ADDENDUM  
PAGE 1 OF 1

OWNER:	Michigan State University 1147 Chestnut Road East Lansing, MI 48824
ENGINEER:	Fishbeck 5913 Executive Drive, Suite 100 Lansing, MI 48911
DRAWING REVISION NO.:	2
ISSUED HEREWITH:	
SPECIFICATION SECTIONS:	None
SHEETS:	2, 3
SKETCHES	None
BIDS DUE:	Not changed
This Addendum is issued to all Bid Set Holders, is a part of the Contract Documents, and modifies the previously issued Bidding Documents.

RFI Question and Response:

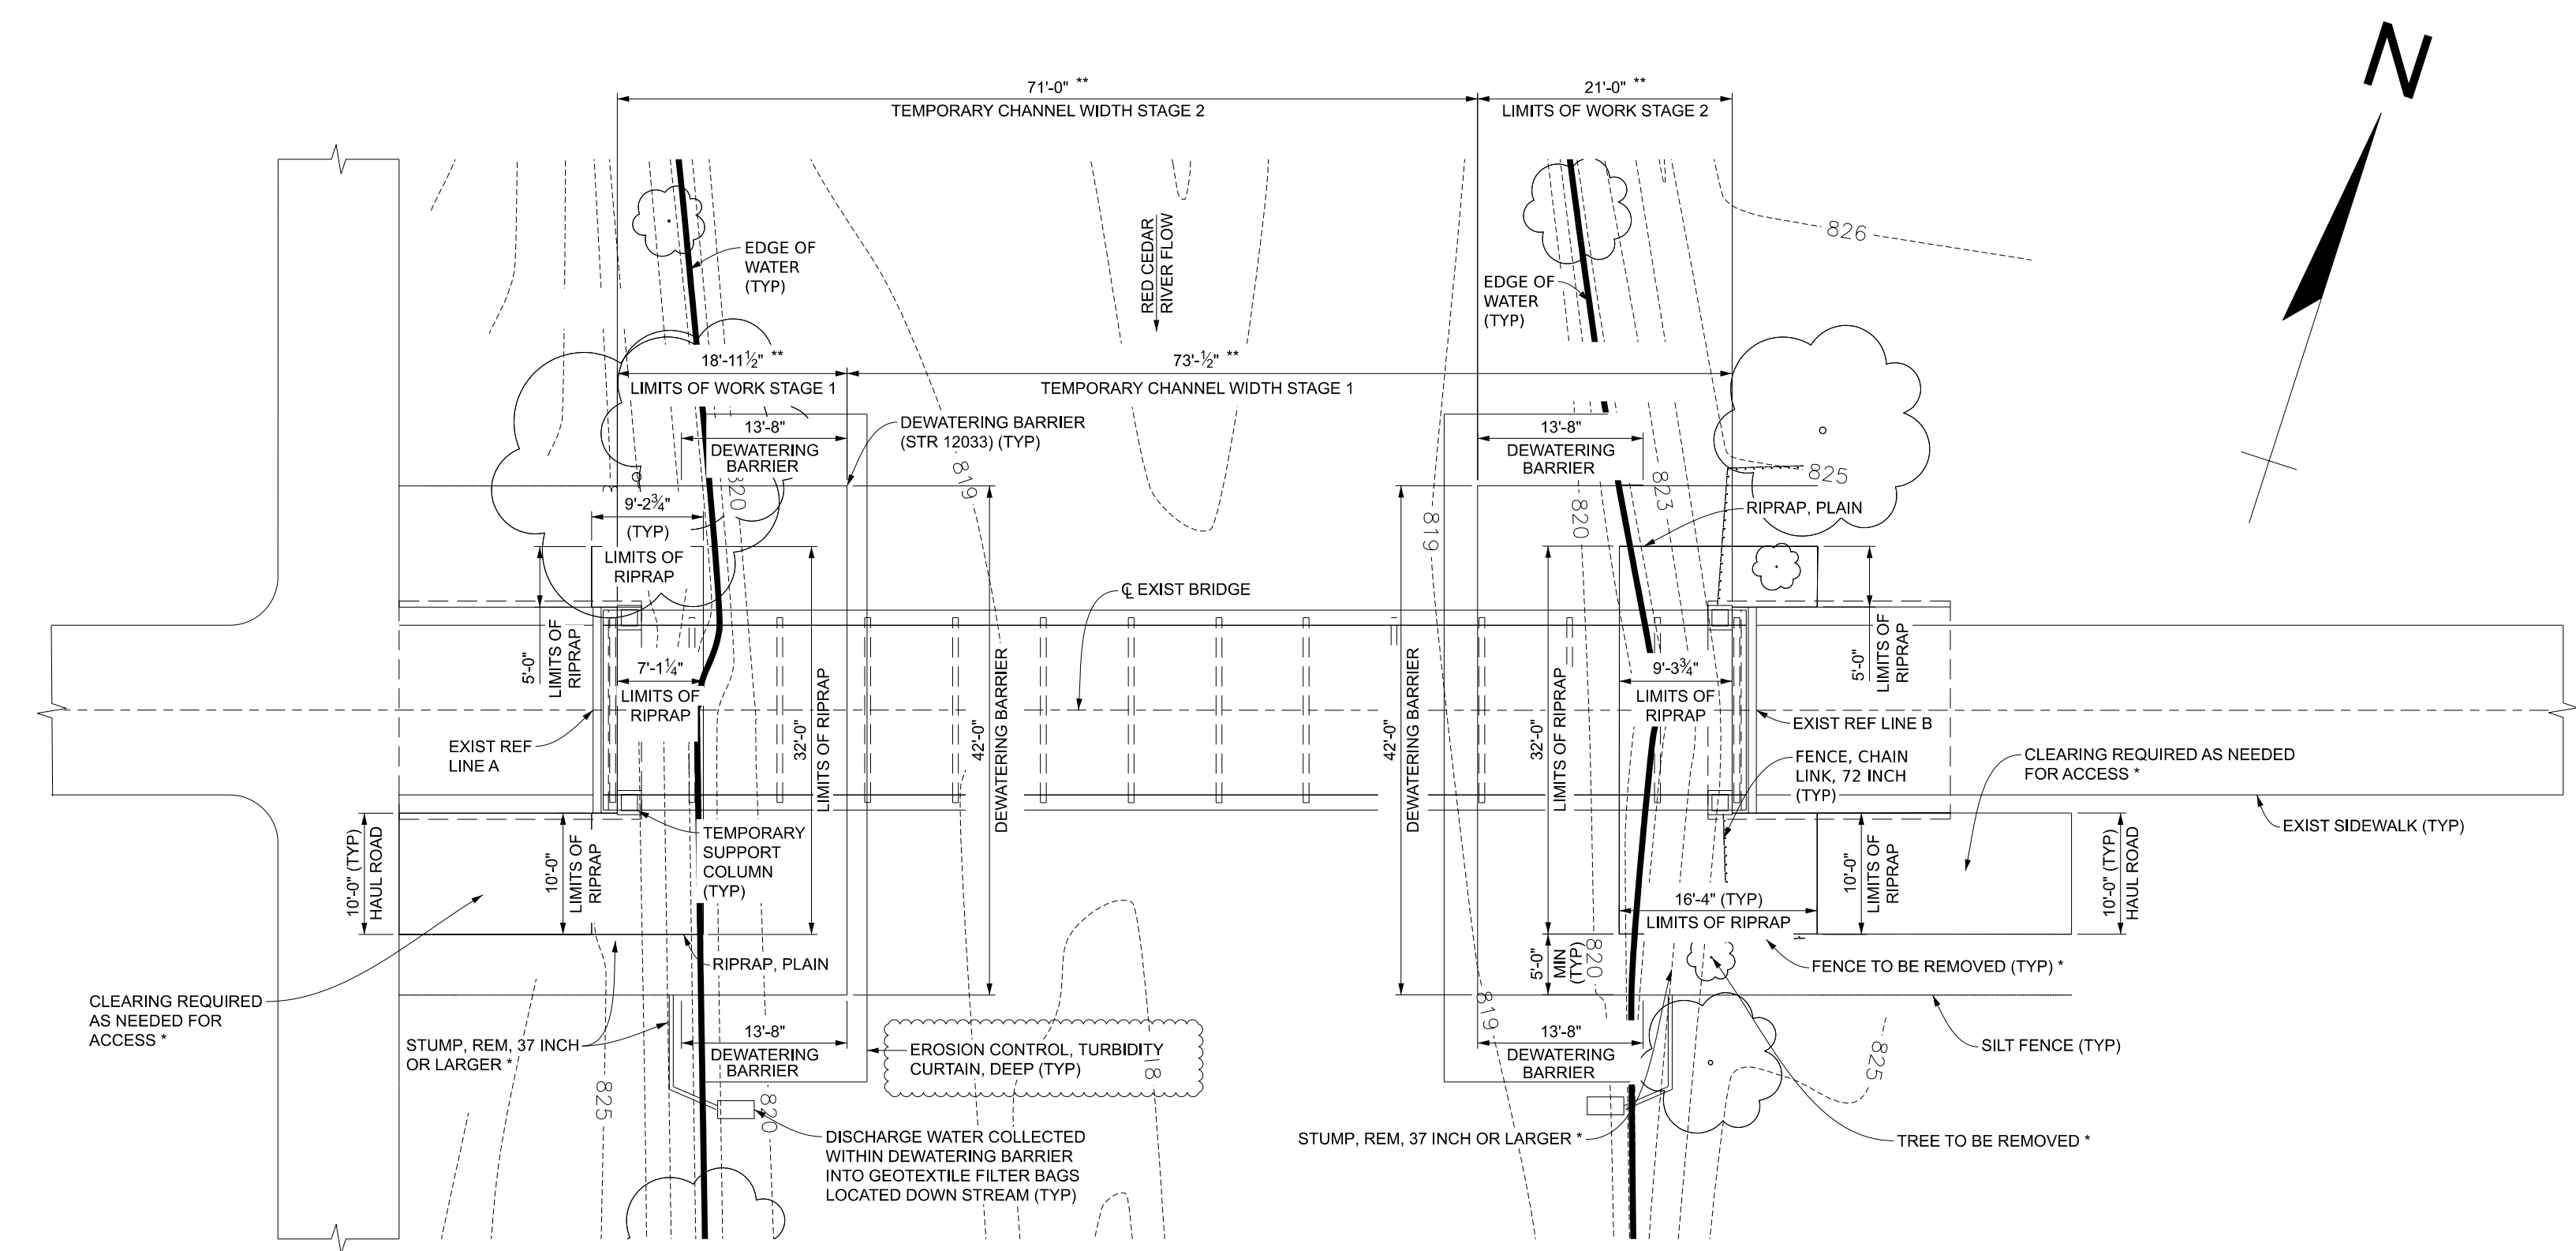
Q: *Are the elastomeric pads supposed to be vulcanized to the bottom of the sole plates or are they loose?*

A. The pads do not need to be vulcanized.

Sheet: 2 GPSTR 001 (reissued)

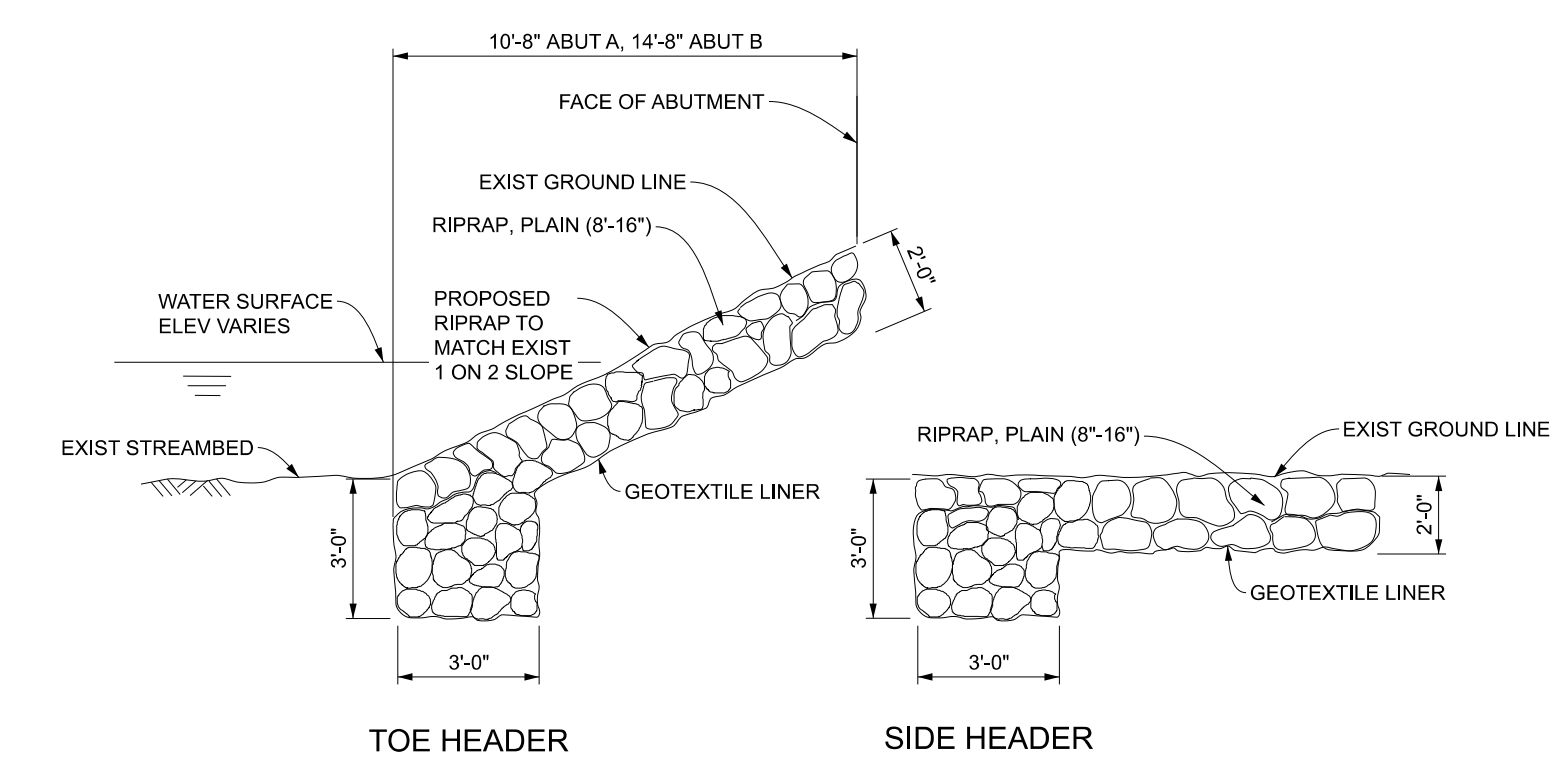
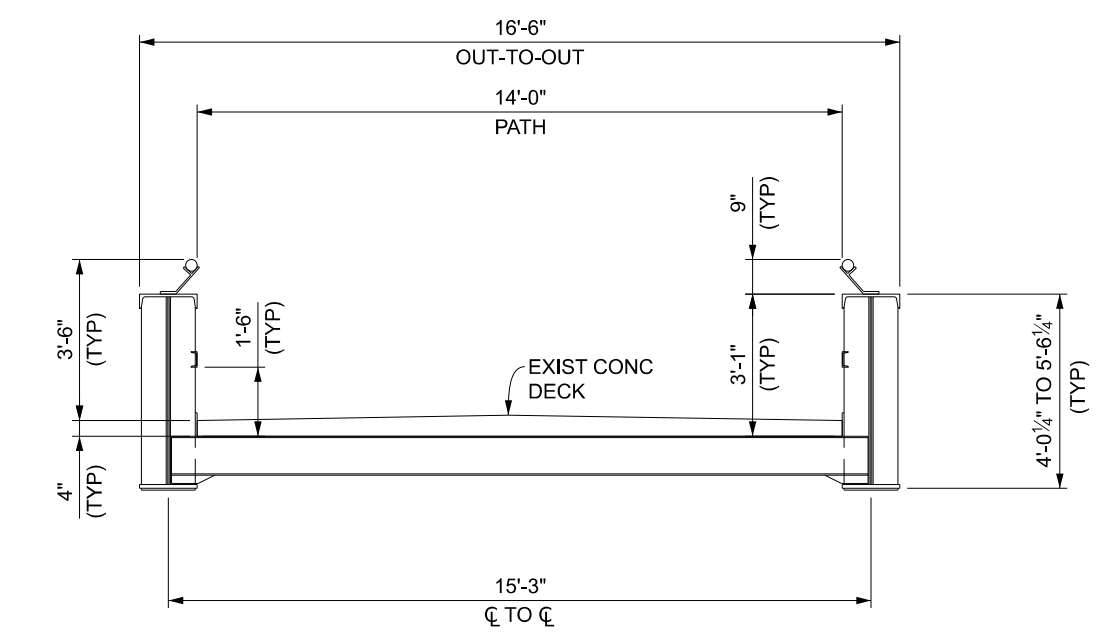
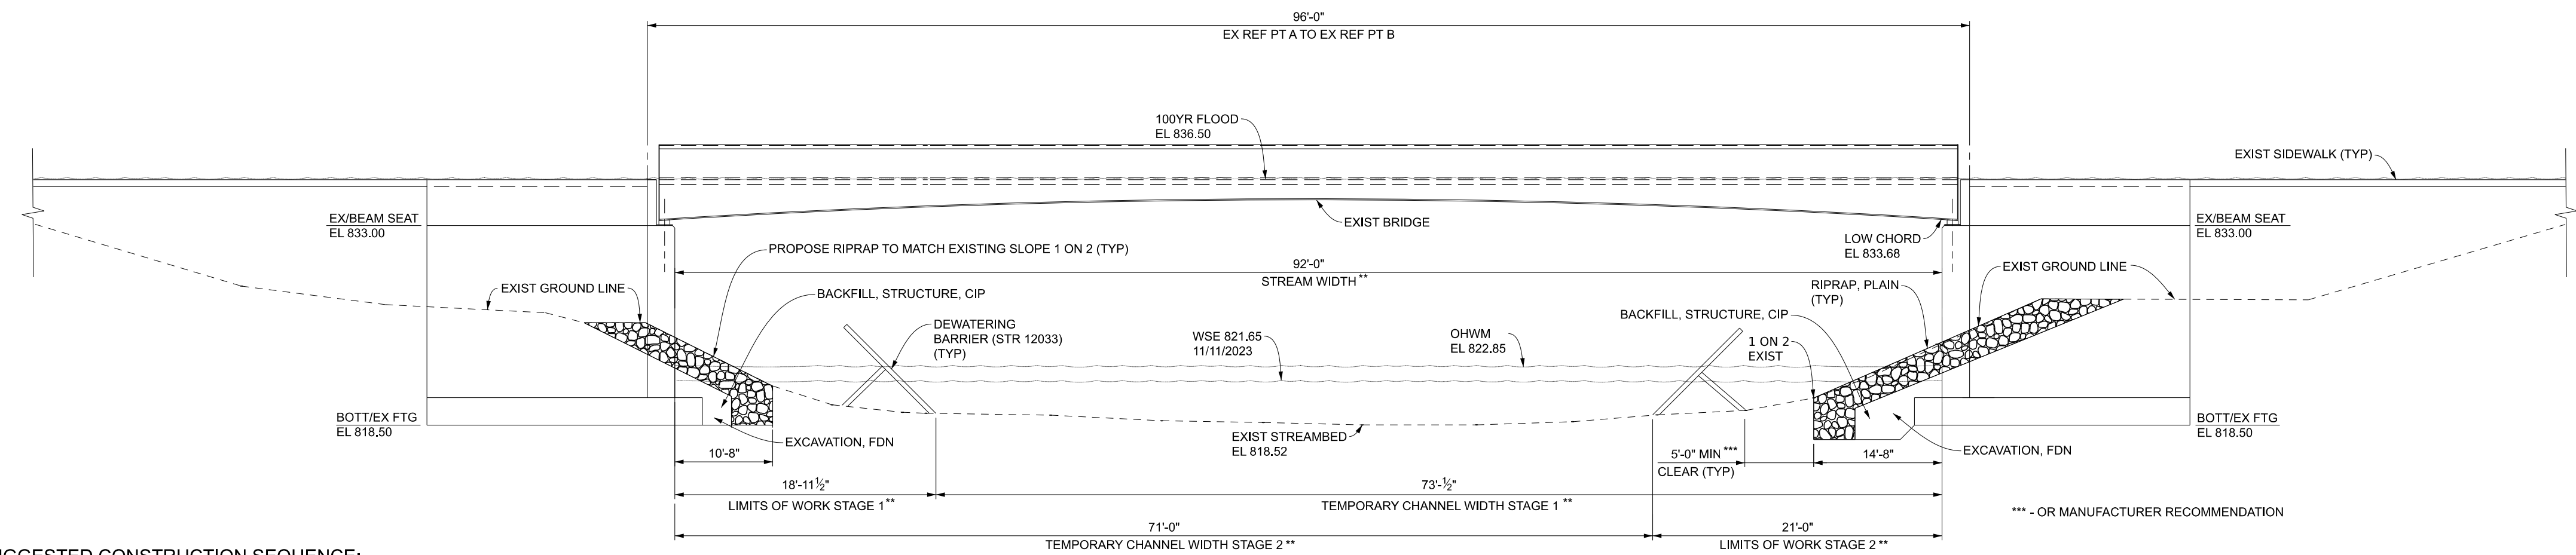
A. Added turbidity curtain to plan view and to miscellaneous quantities. Contractor to provide turbidity curtain.

100 Ft	Erosion Control, Silt Fence
2 Ea	Erosion Control, Filter Bag
170 Ft	Erosion Control, Turbidity Curtain, Deep

Sheet: 3 REM 001 (reissued)

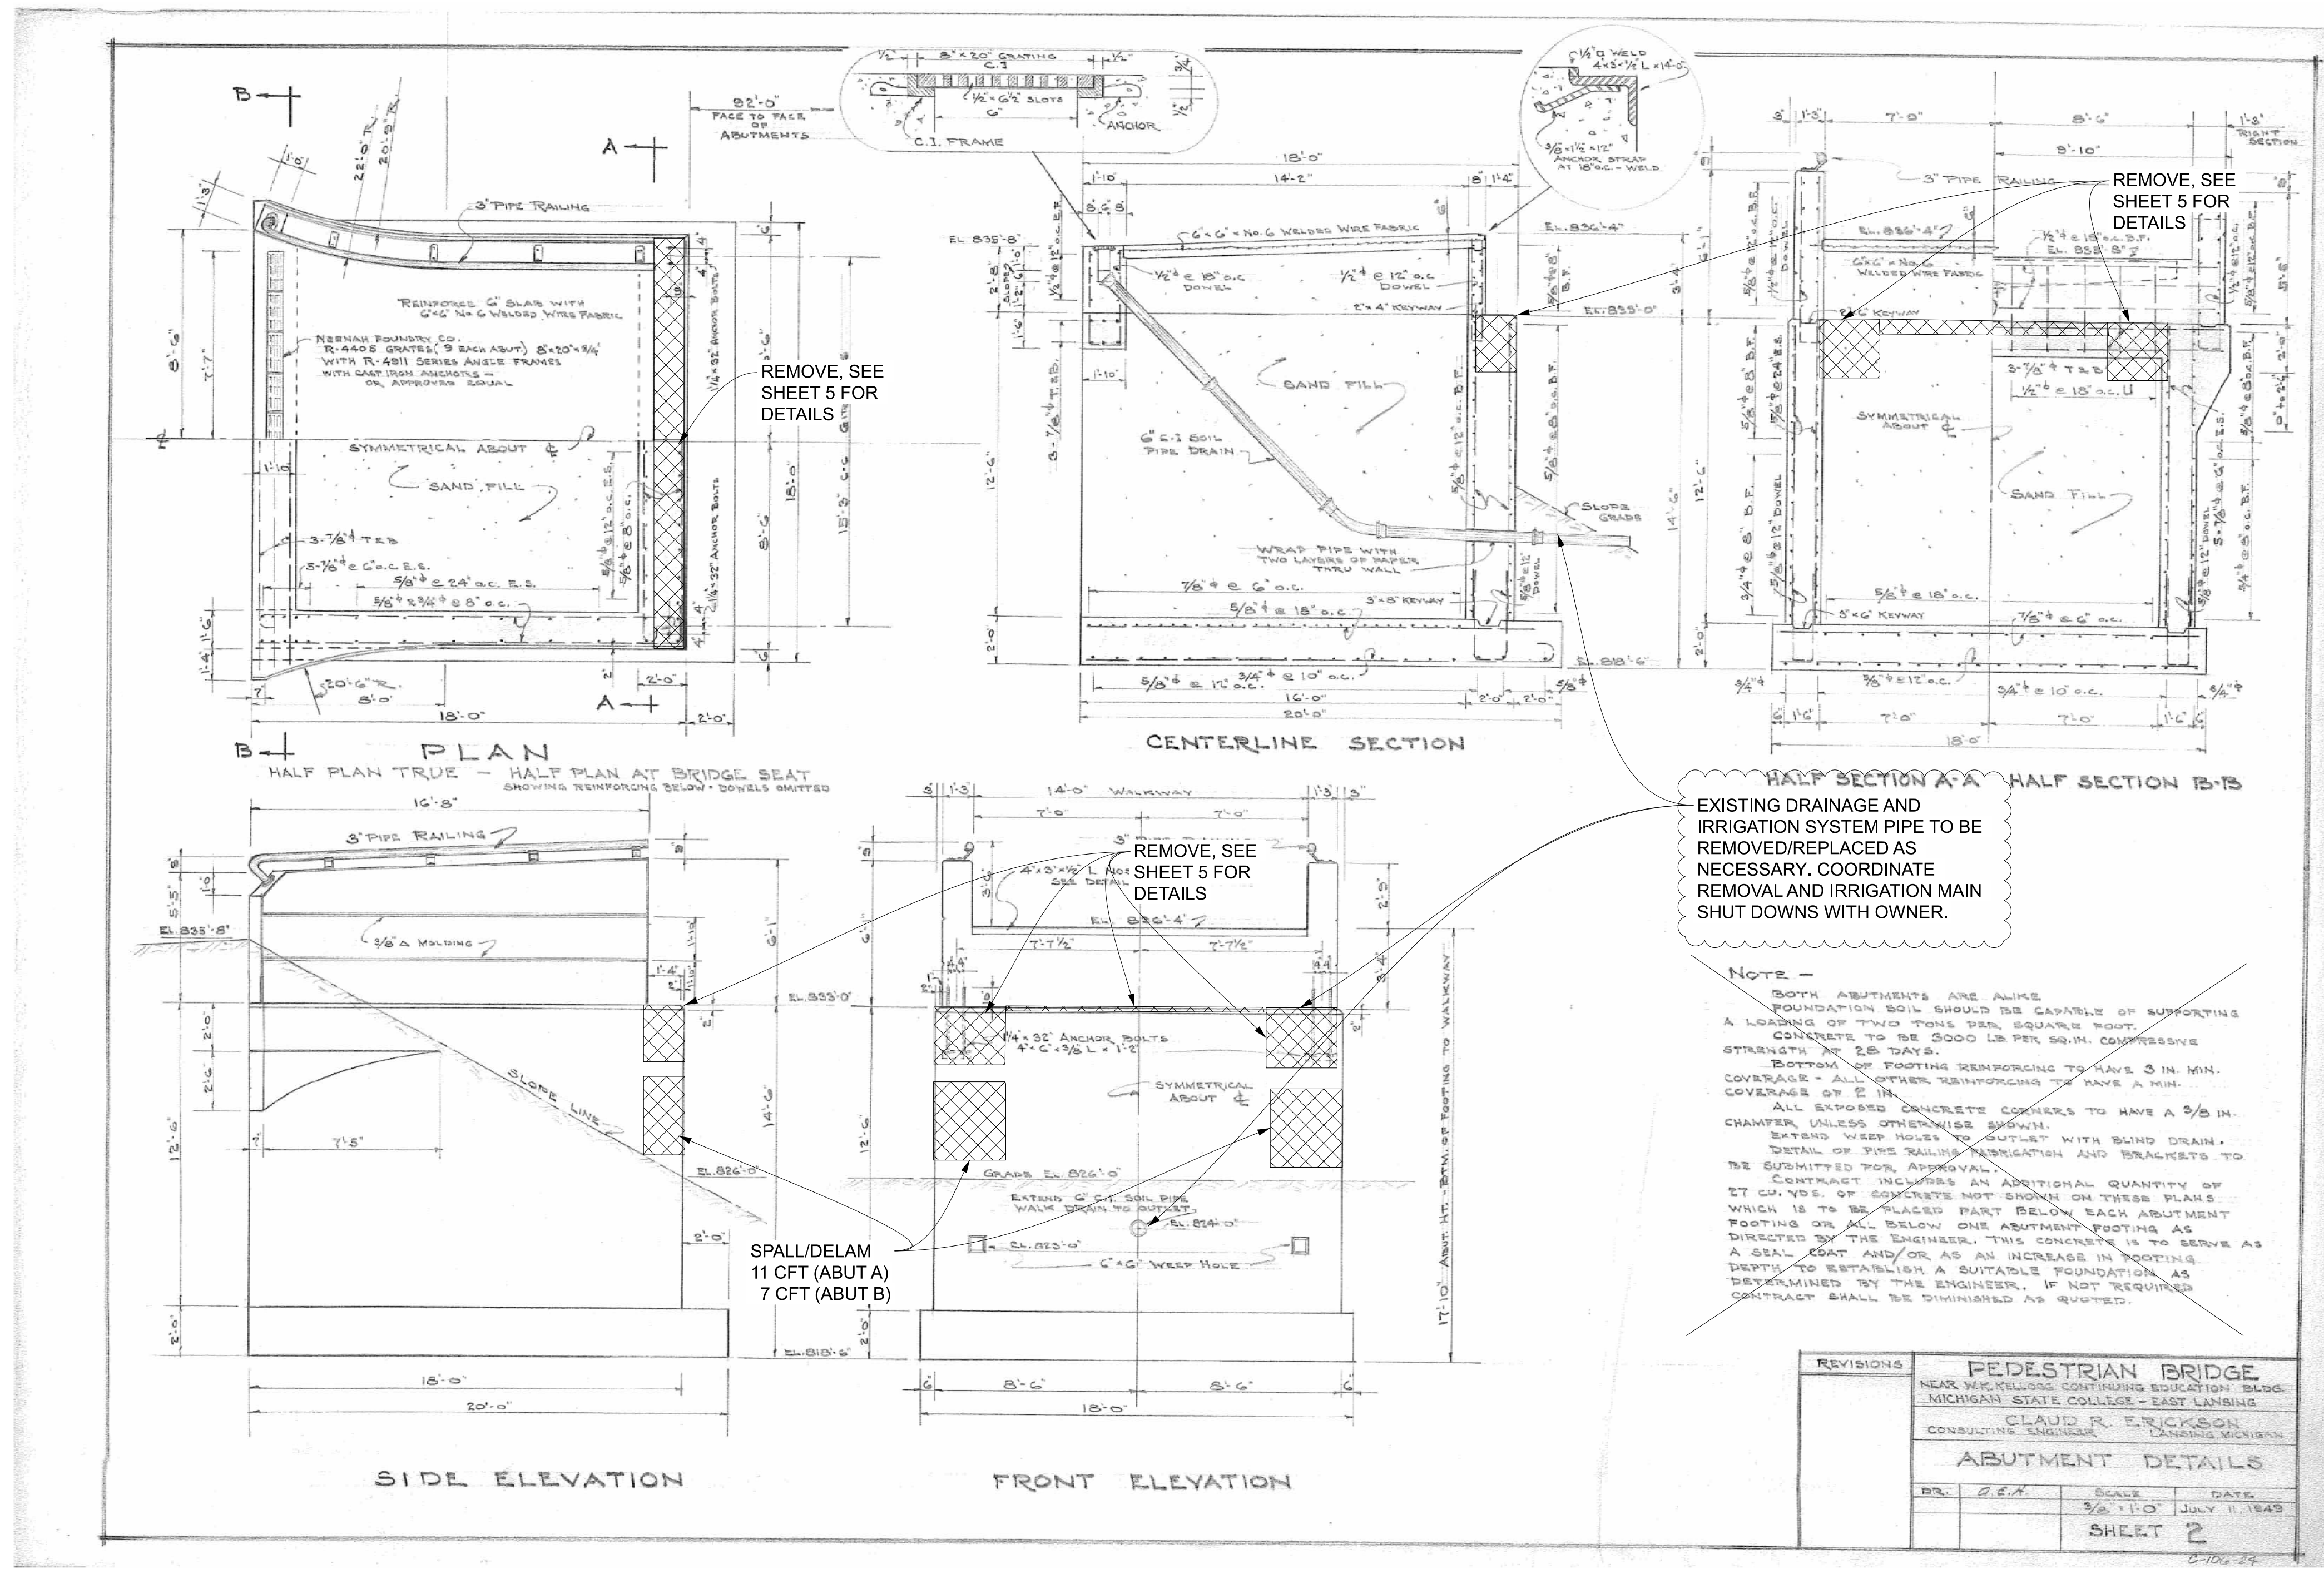
A. Note has been revised for drainage/irrigation pipes to remove/replace any conflicts and to contact owner for such work.

EXISTING DRAINAGE AND IRRIGATION SYSTEM PIPE TO BE REMOVED/REPLACED AS NECESSARY. COORDINATE REMOVAL AND IRRIGATION MAIN SHUT DOWNS WITH OWNER.

EXISTING DRAINAGE AND IRRIGATION SYSTEM PIPE TO BE REMOVED/REPLACED AS NECESSARY. COORDINATE REMOVAL AND IRRIGATION MAIN SHUT DOWNS WITH OWNER.
